Dato:		BERNIC A/S	
24-Jul-05			
Skala:	Kunde:	Sheet 1 of 1	
1:000			
Titel:		Materiale:	Forve:
		PC	
Emne nr.:	3D model:	Tegn. nr.:	
8.845.525.111	SEP_PLATE_3_MOD	BC 66	
Beskrivelse:		Fil:	
Type 525 plate (behind terminals)		SEP_PLATE_3_MOD

SECTION A-A

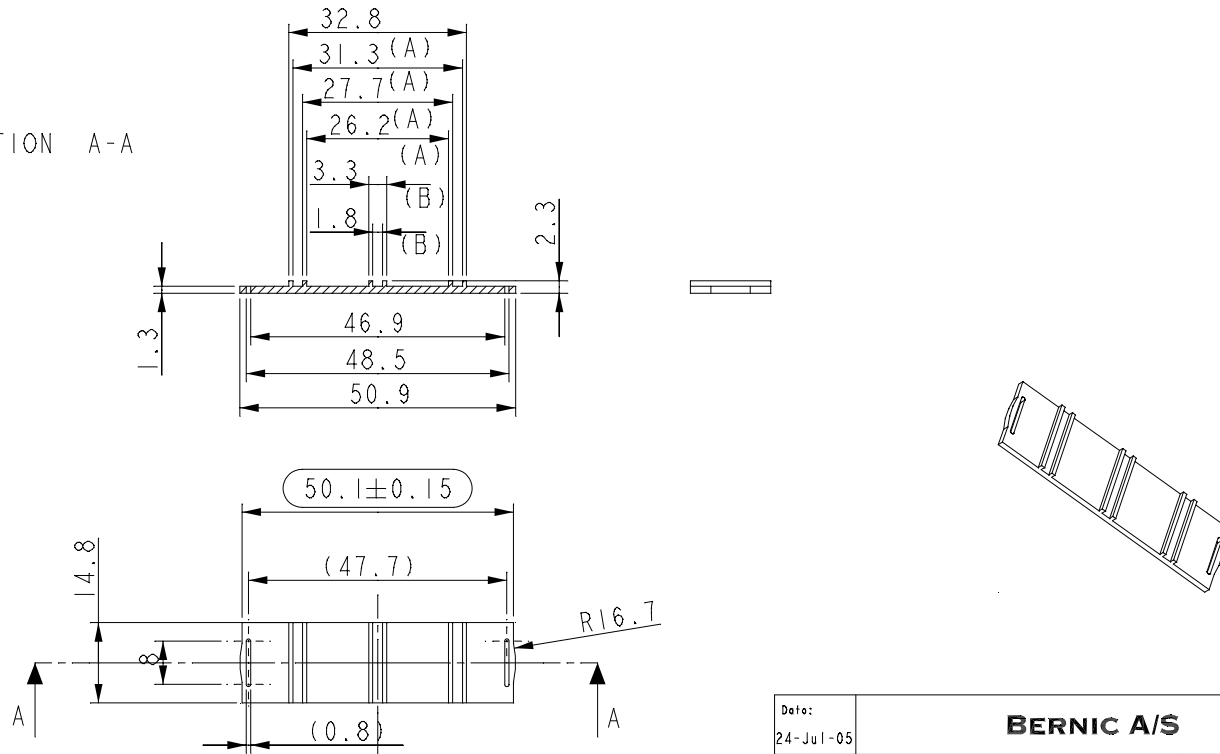
Revision date and number		Description
28.01.2006	A	Measures 26,2- 27,7- 31,3 and 32,8 changed from 36,2- 37,7- 41,3 and 42,8)
05.02.2006	B	2 ribs added
